RE: Water Licence 2AM-MRY1325 January 2019 Inspection Report

WATER LICENCE INSPECTION FORM

Table A.1 - Response to CIRNAC Water Licence Inspection - January, 2019

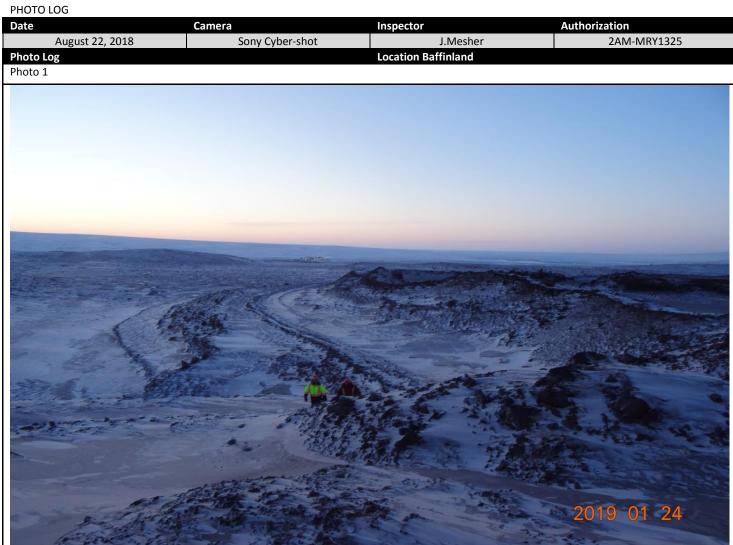
- a. At the time of the inspection, the majority of the waste and water management structures at this facility were snow covered making it difficult to identify and potential concerns.
- b. The licensee is currently in the process of clearing iron ore away from the ditches and is re-installing the required buffer zone between the ditches and the stockpile to allow single lane traffic. The licensee has committed to completing this work prior to May 15, 2019.
- c. No other concerns were noted at the time of the inspection.

Description: Inspector Jeremy FRASER and Chase, Manager of Ore crusher pad, walk parameter of crusher pad. Managers have verbally agreed to have Ditching and single lane traffic road to be constructed prior to May 15 2019.

ITEM No. ¹	Action Required with Observation or Item of Concern	Baffinland Responses
Section	1	
1.b.	The licensee is currently in the process of clearing iron ore away from the ditches and is re- installing the required buffer zone between the ditches and the stockpile to allow single lane traffic. The licensee has committed to completing this work prior to May 15, 2019. (see photo 1)	Baffinland continues to remove ore stockpiled within 3m of the perimeter ditch and re installing the required buffer zone between the ditch and ore stockpile. Work was carried out following the January 2019 insepection, however due to frozen conditions encountered, work was suspended. This is an ongoing activity as conditions permit, and will be assessed in spring 2019. Baffinland endeavors to reinstate this 3m buffer over the 2019 season once temperatures are favourable.
